HORSHAM DISTRICT COUNCIL CONSULTATION

TO:	Horsham District Council – Planning Dept
LOCATION:	South Lodge Hotel Brighton Road Lower Beeding West Sussex
DESCRIPTION:	Application for Approval of Details Reserved by Conditions 10, 11, 12, 14 to approved application DC/22/1205
REFERENCE:	DISC/24/0092
RE-CONSULTATION:	1st set of comments in black 2nd set of comments in blue 3rd set of comments in green
RECOMMENDATION:	More Information / Modification More Information / Modification More Information / Modification

External lighting

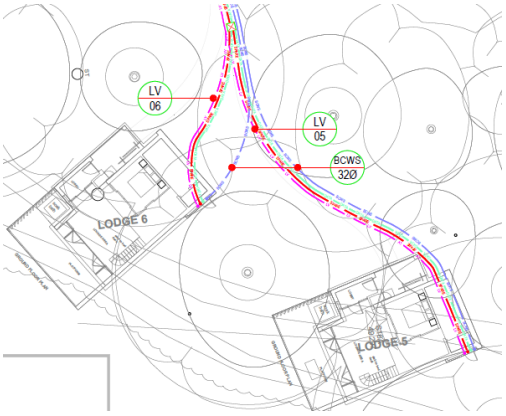
13. Due to potential light intrusion within the rural setting, there is concern with the proposed scheme as well as the limited information regarding hours of use. Based on guidance from SDNP Dark Skies Technical Advice Note Version 2 and The Bat Conservation Trust guidance note 08/23, we recommend the following for external lighting in a countryside location to mitigate adverse landscape effects:

a. 3000Kelvin or lower
    b. 500 Lumens or below
    c. Shielding such as cowls, baffles or back shields to limit visibility beyond pathways.
    d. Where appropriate, use of motion/proximity sensors and set to as short a possible a timer as a risk assessment will allow. For most purposes, a 1 or 2 minute timer is appropriate.

e. Horizontally mounted luminaires with no light output above 90° and/or no upward tilt – for example, single sided distribution bollards at a spacing of 11m and a height of 1.3m allowing paths to be lit to adoptable standards.

Some information provided with thanks. While we note the likelihood of wildlife triggering the PIR, we would still recommend a 1 or 2 minute timer is more appropriate than an always-on approach, given the light intrusion within the rural setting. As above, please provide information regarding hours of use. Closed, with thanks.
14. There is additional concern with light spill from the use of the lodges.
    a. The proposed windows are floor to ceiling in height which are likely to cause a large amount of light spill, reducing the rural character. We recommend that black out blinds are installed, although we are wary of the enforceability of this measure. Closed.
